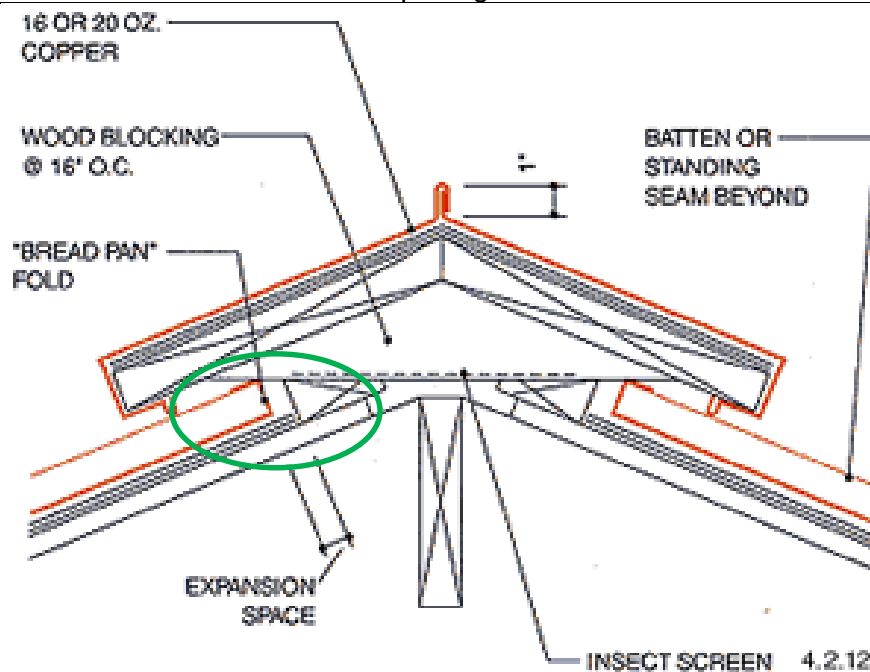
Flue over fireplace is not properly wrapped. Sealant was improperly spread all over base of flue in an attempt to prevent leakage. This sealant is not designed as a roof or flashing membrane and will not last, creating a maintenance condition. See attached detail for proper flue flashing technique.

Sealant was used behind flue. Again, a maintenance condition was created.

## METAL VENTED RIDGE DETAIL

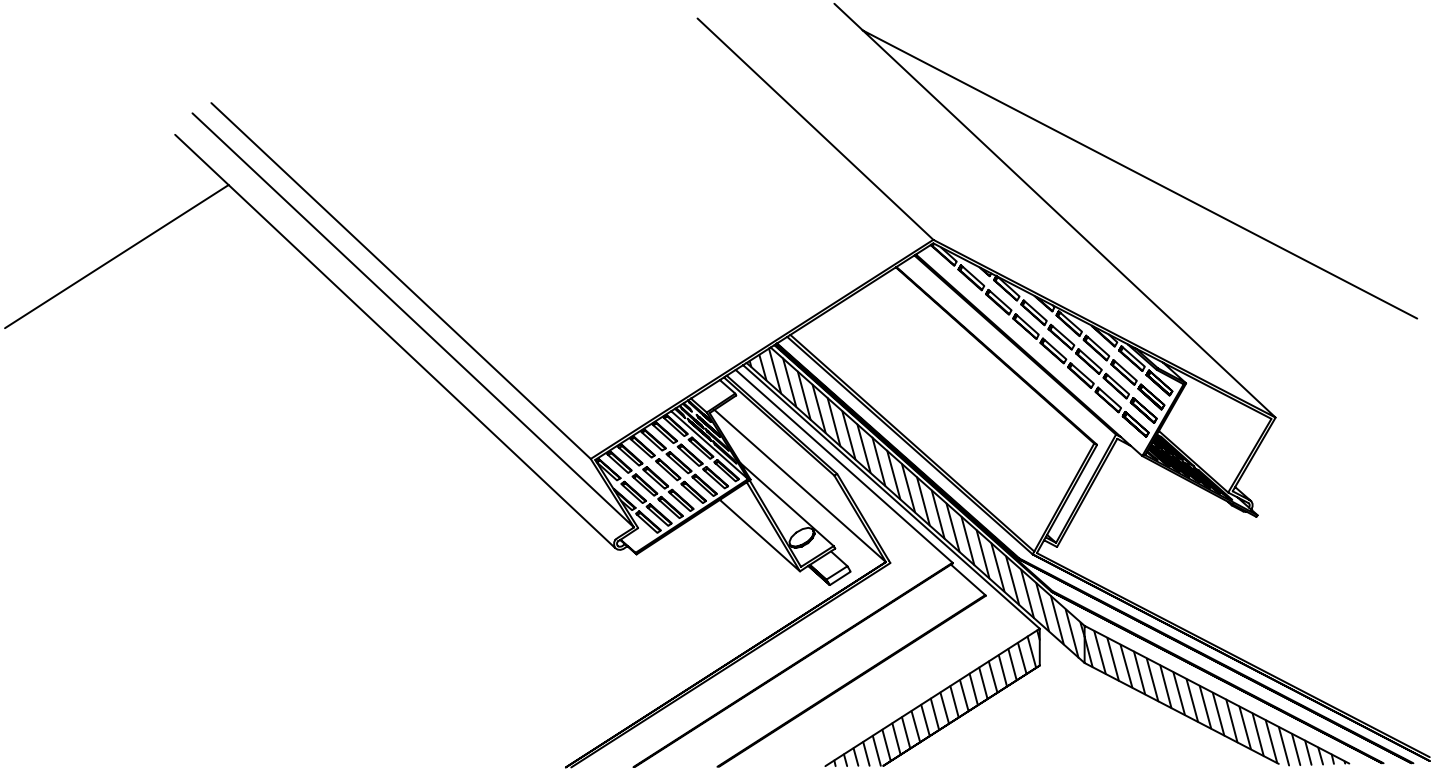
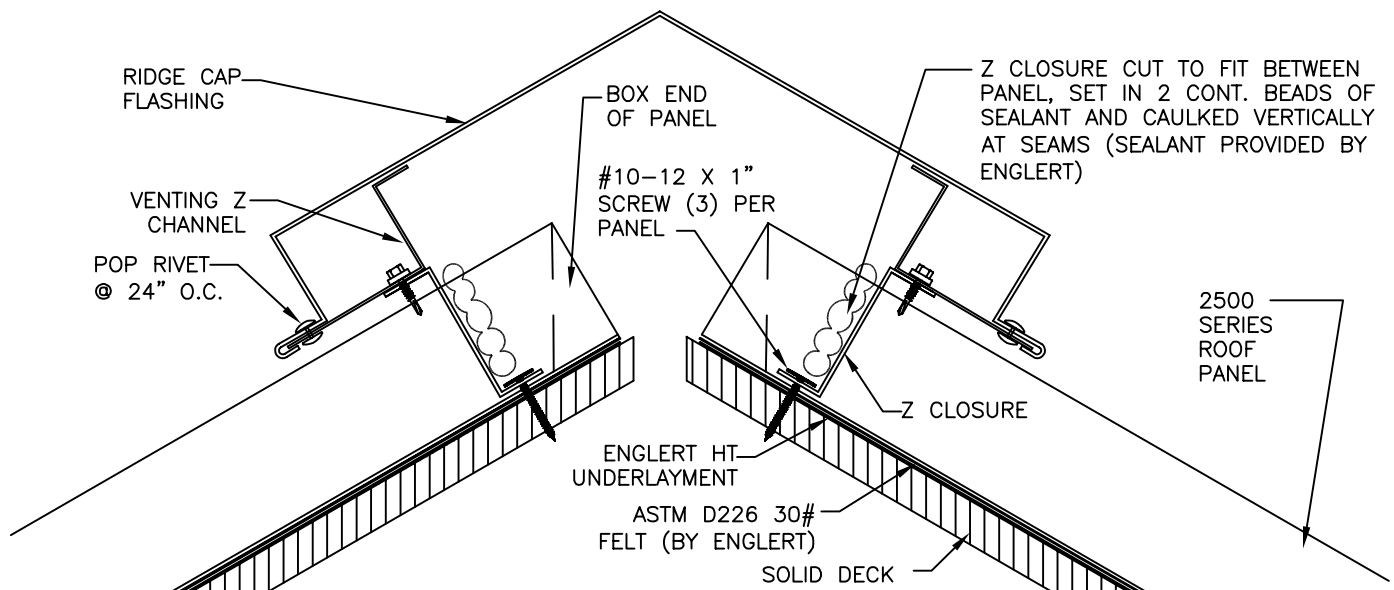
No protection from windblown precipitation at vent system. Top of pan was not boxed up as shown in detail below with a "bread pan" fold. No vertical closure was installed on panels below vent opening in the deck.

Typical venting system for the peaks of metal panel roofs. There are numerous designs similar to this detail that all have a vertical baffle of some sort to prevent windblown precipitation from entering the vent.

GAF MATERIALS CORPORATION www.gaf.com	 ROOF PENETRATION SERIES	EXPOSED WOOD EQUIPMENT SUPPORT SLEEPER	DRAWING # 511	SYSTEM FD
			SCALE N.T.S.	ISSUE/ REVISION DATE 3-1-10

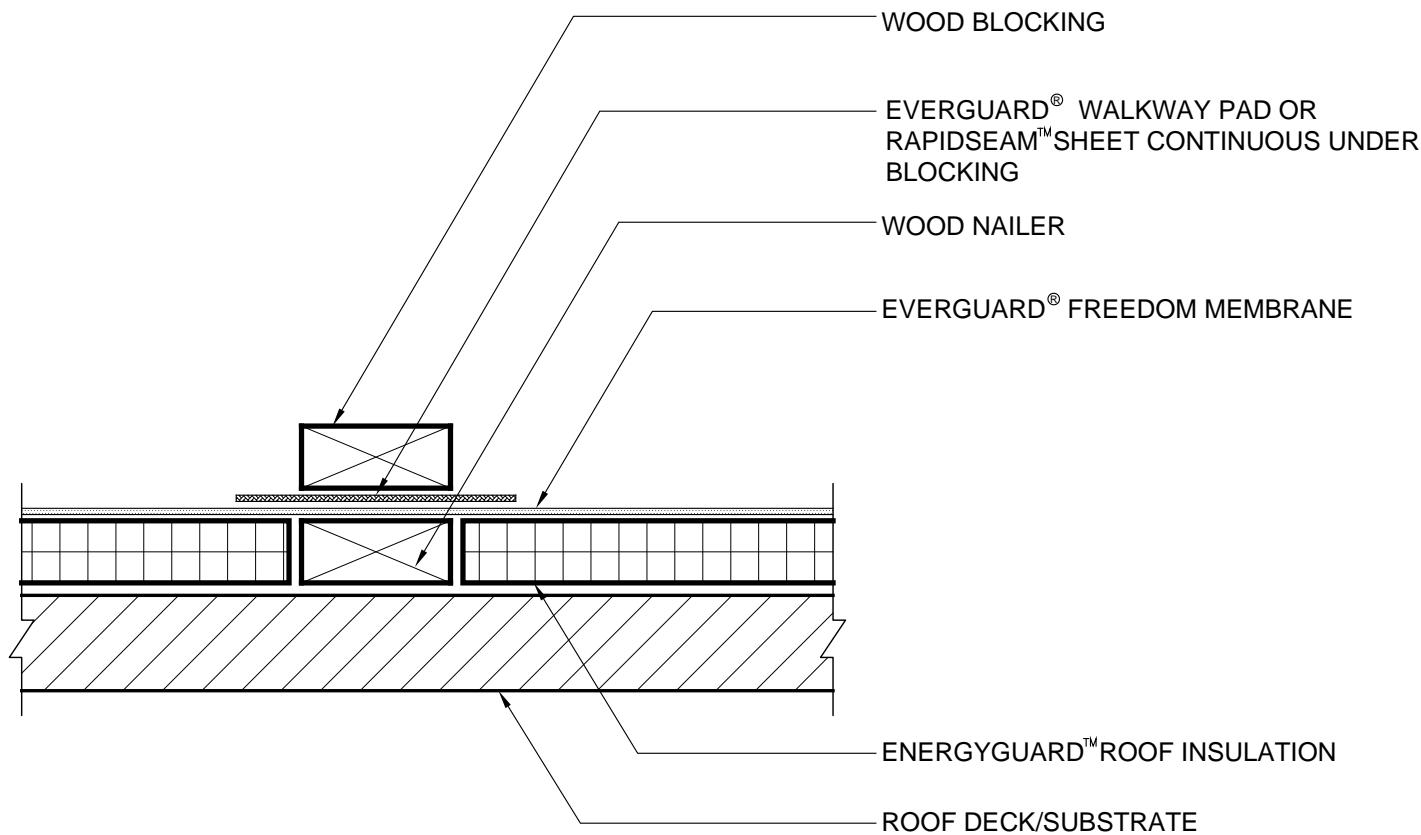
was attached to the bottom of the sleepers (to protect the membrane), the narrow (2") side of the sleepers are resting directly on the roof. The narrow edge of the sleeper will now likely depress into the roof system creating troughs. Wood sleepers that are installed over an insulated single ply roof system require that wood blocking be installed under the wood sleepers in place of the insulation (see below, GAF TPO detail and Carlisle EPDM detail). This wood blocking below the membrane is to properly support the wood sleepers and prevent depression in the roof system. When installing overburden of this type on an insulated roof, the over burden must be designed to have its weight spread out to ensure the overburden does not depress into the roof system. This is especially necessary when the wood blocking under the membrane is not installed to support the overburden. Again, if wood blocking is installed under the membrane located directly under the overburden, the overburden will not depress into the roof system (as shown on the below details). The depression that will occur on this roof will now fill with ponding water. The water that does not drain from beneath the sleepers will now cause accelerated deterioration to the wood and roof system, with the worst damage due to the freeze and thaw of this water during the winter months.
